**ADDENDUM #5**

**Will County Health Department**  
**BID PACKAGE #2 – Misc. Steel/Structural/Enclosure**  
**November 15, 2018**

**SECTION 00 91 07  
BP #2 - ADDENDUM NUMBER 5**

**PROJECT:**           **WILL COUNTY HEALTH DEPARTMENT - NEW HEALTH DEPARTMENT  
BUILDING  
501 ELLA AVENUE  
JOLIET, ILLINOIS 60433**

**ROOF PLAN** ①  
SCALE: 1/16" = 1'-0"

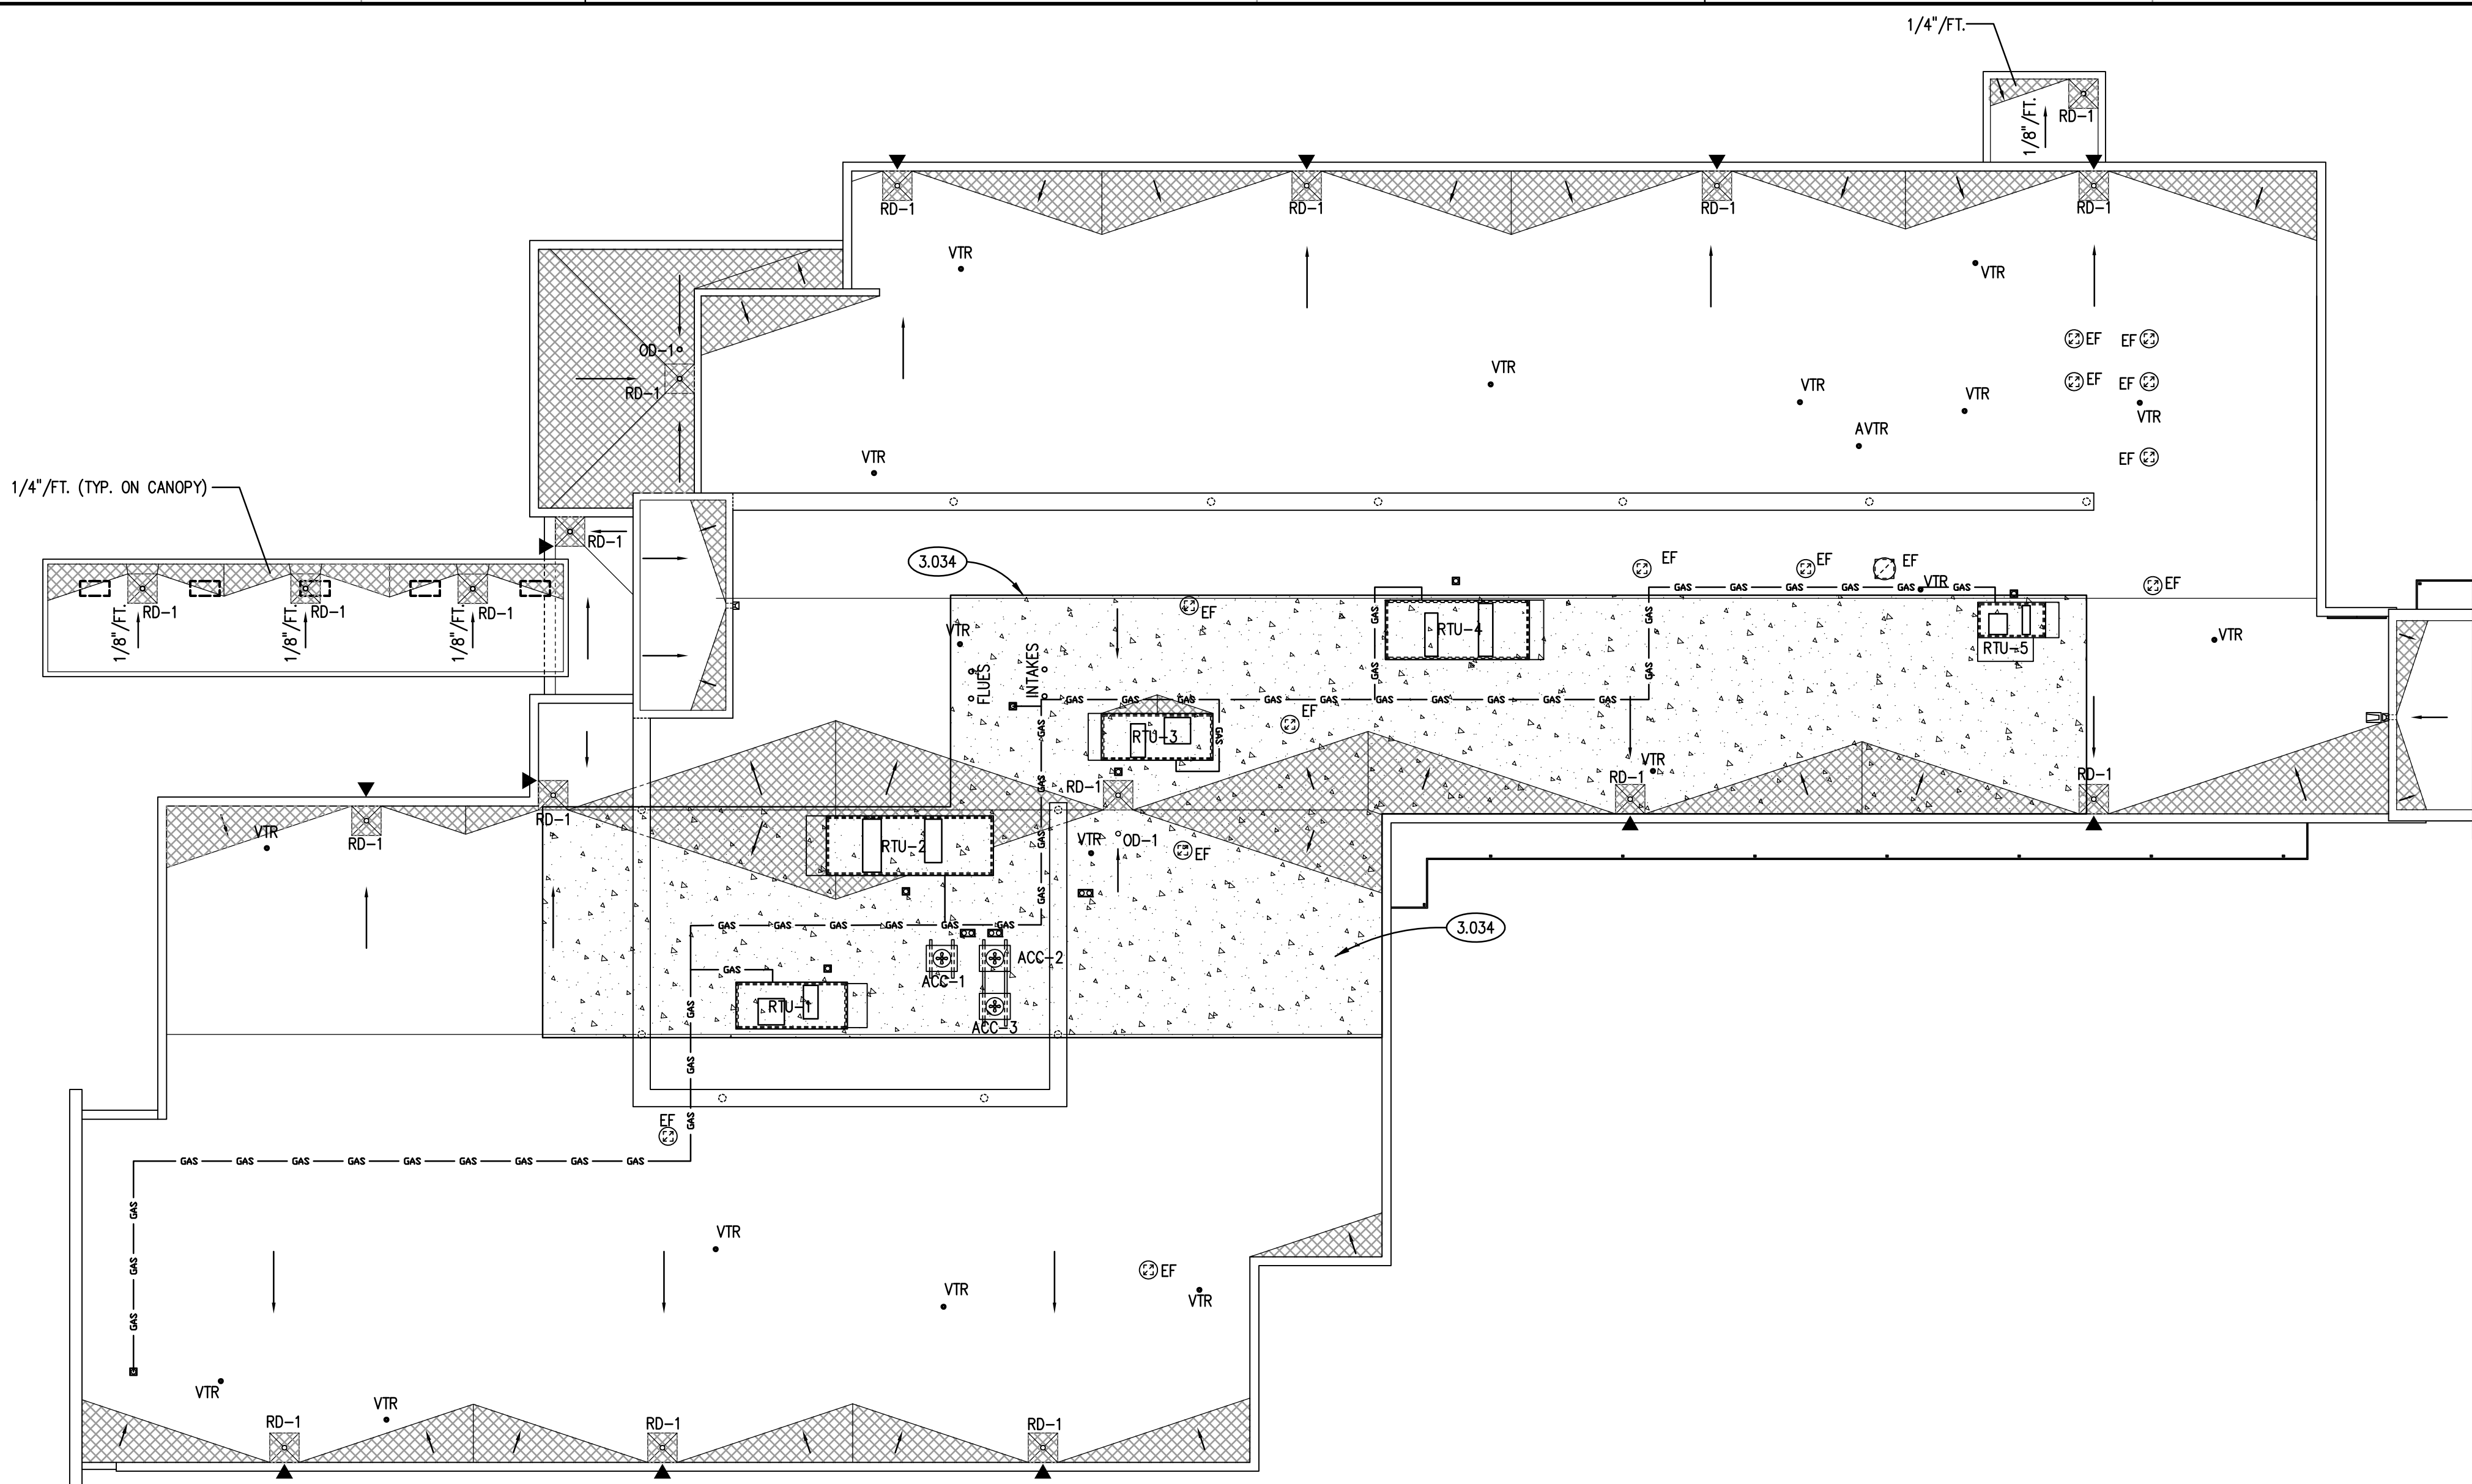
- A. Detail 1/A330: Revised ACC Unit quantity to three (3) as noted (ACC-1, ACC-2 & ACC-3), roof portal and roof curb extents east of RTU-1 as clouded.
- B. Detail 1/A330: Properly located all vents thru roof locations to coordinate with future Bid Package Release. Refer to revisions cloud 9.
- C. Detail 1/A330: Added roof drain tags.
- D. General Notes: Deleted General note #7.
